This gallery shows some pictures of bad solderings - they should prevent you from making the same errors (feel free to add even more pictures here!)

Permanent link:
https://midibox.org/dokuwiki/doku.php?id=bad_solderings_gallery

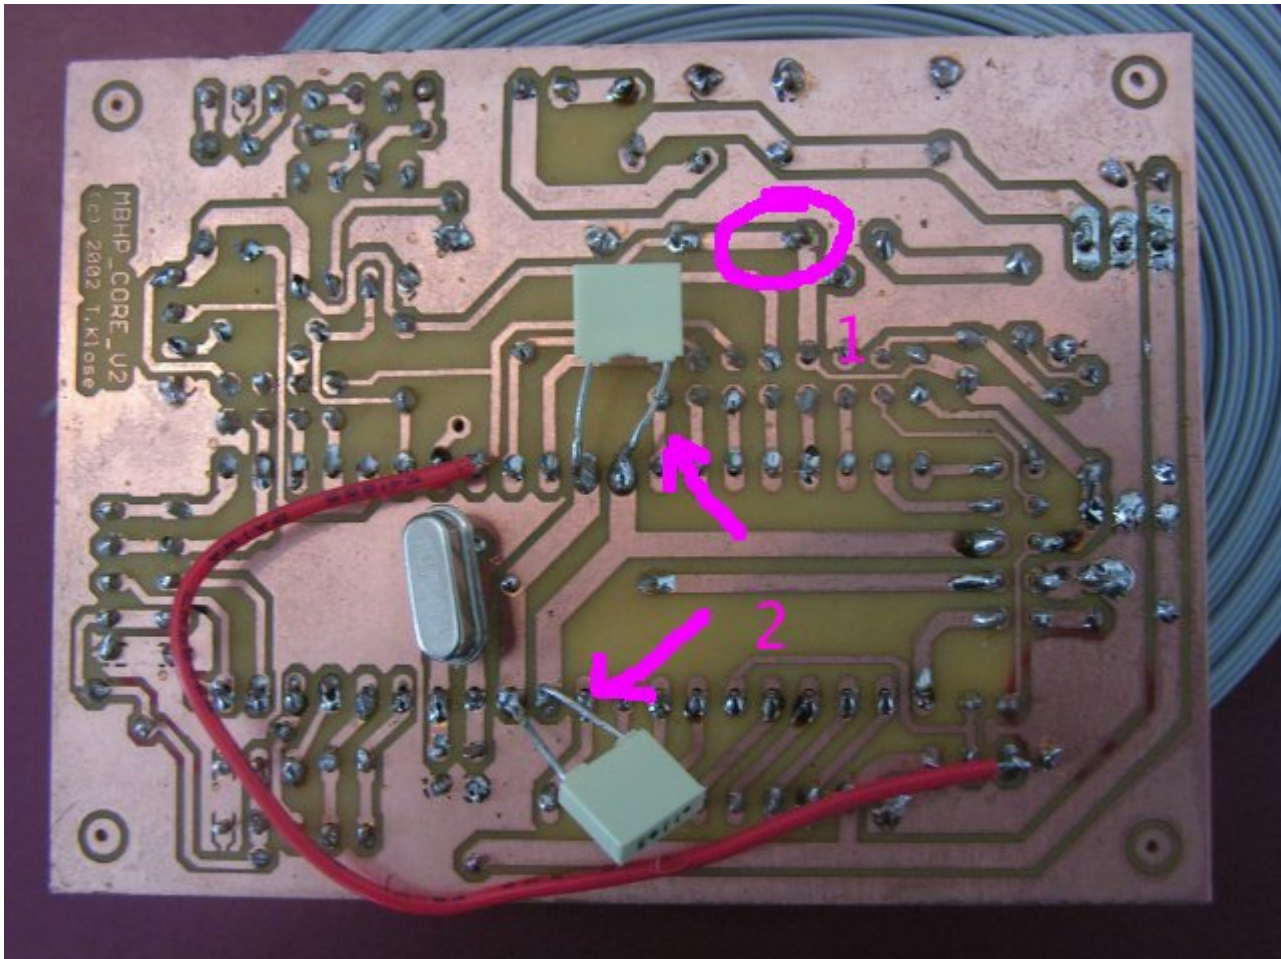
1: The core module has some badly soldered connections(loose), which could lead to failures. There are also missing solderings (e.g. 33pF cap below crystal). It makes sense to solder each pad again, the [Soldering](#) guide in the Wiki gives some useful tips

2: The legs of the caps should be cut, otherwise they can cause a short circuit which can damage the PIC!

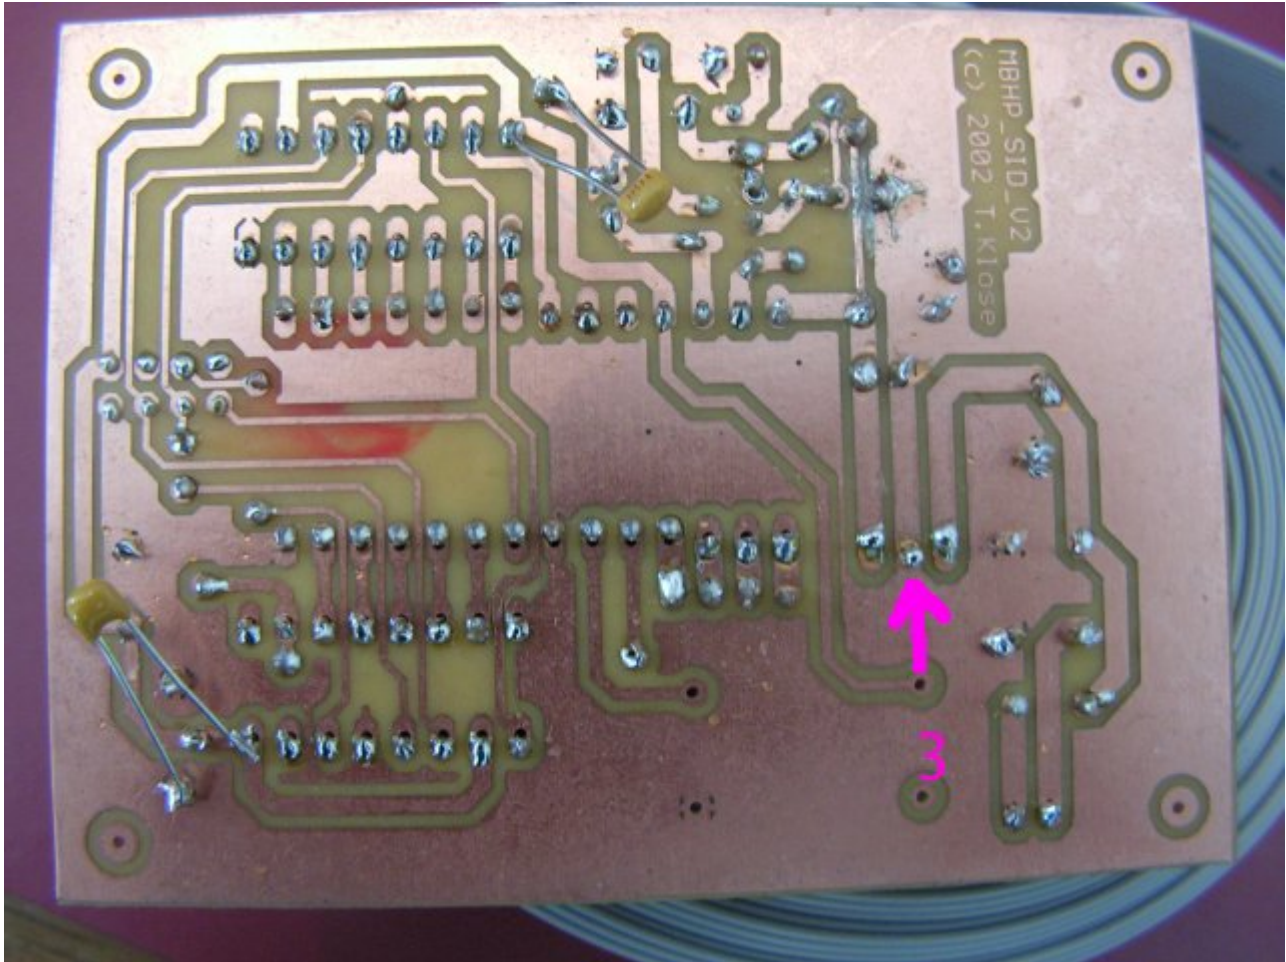
3: This seems to be a bad ground connection directly at the 78xx - it can lead to the wrong voltage. Here the same: just solder the pads again, it will help
And same as above: the long cap legs need to be cut, the danger of shorting out is too high!
